Our Ref:239848
Department Ref: SSD-9827

**RE: PART LOT 4 DP 1238761
45 HONEYSUCKLE DRIVE, NEWCASTLE.**

Thank you for your letter dated 21 February 2020 providing the Departments request for additional information in relation to the above application following further assessment. Please accept this submission as our formal response to the matters raised.

Figure 1 – Photomontage showing a compliant scheme and proposed development.

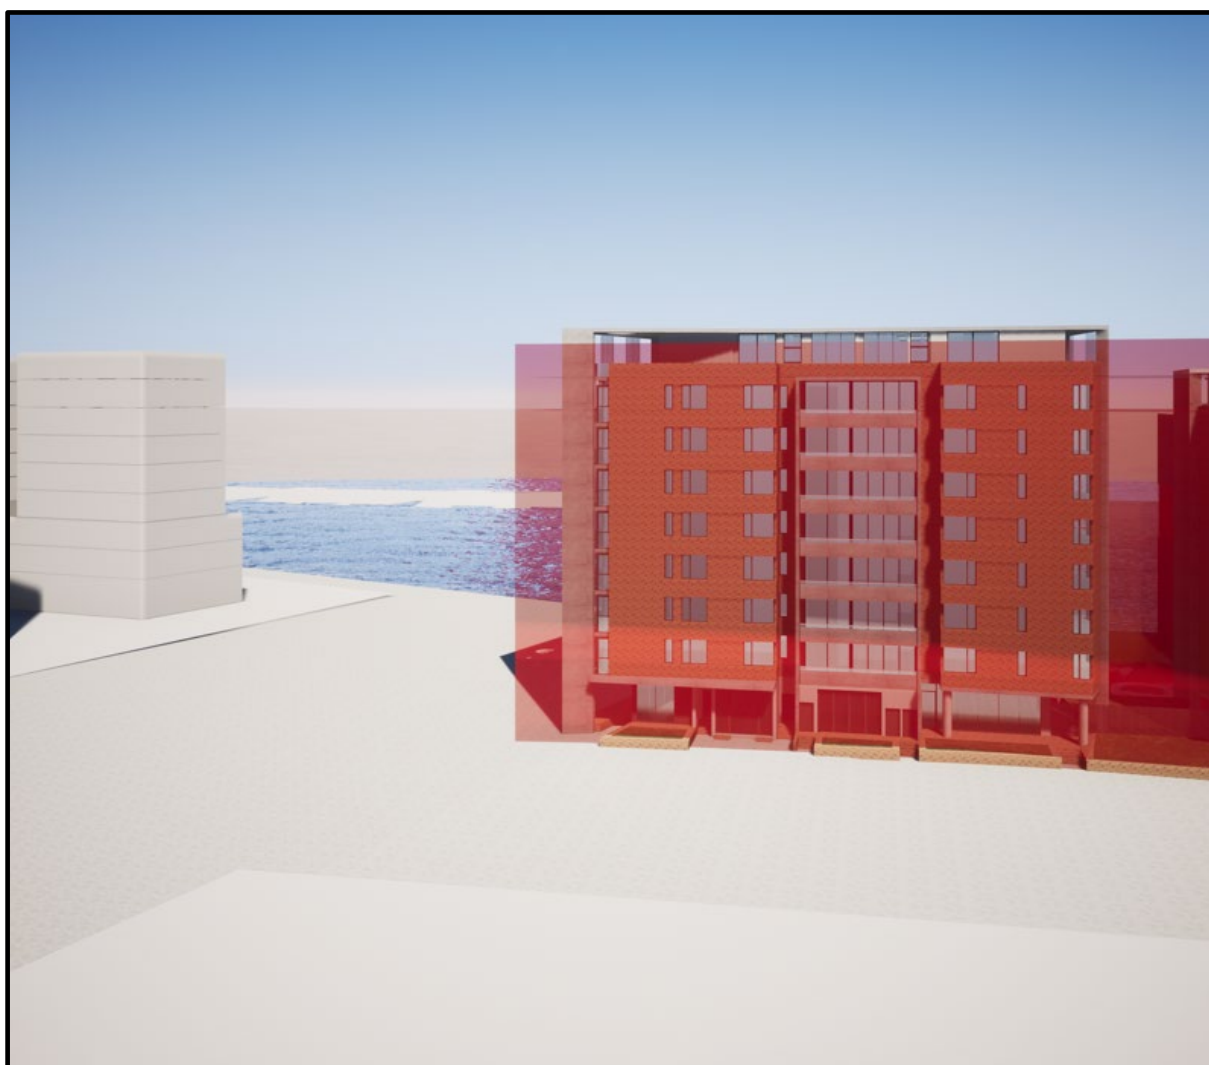
Provide an assessment of view loss impacts, using Tenacity Principles, to the residential apartments and hotel rooms of the approved development at 42 Honeysuckle Drive. The assessment should consider the current proposal as well as an LEP compliant scheme.

However, because the proposed development footprint has been reduced and because a more slender built form with separation between the three (3) buildings the retained views from 42 Honeysuckle Drive are improved. Views from 42 Honeysuckle Drive will be available through the site and via the available space along the Cottage Creek corridor as shown on the below photomontage, which outlines a compliant scheme (in block form) and the proposed development.

Horizon proposes three (3) distinct buildings, with open garden courtyards between the buildings. This allows much better visual connections from Honeysuckle Drive to the harbour, and much better solar access to this significant street. This is a key design feature to prevent a solid built form screening the harbour from the City, the design is an example of reasonable view sharing. Importantly it also allows properties deeper within Newcastle's urban fabric to retain more connection to the harbour.

The additional proposed building height has no perceptible impacts on views as any views it blocks are skyward.
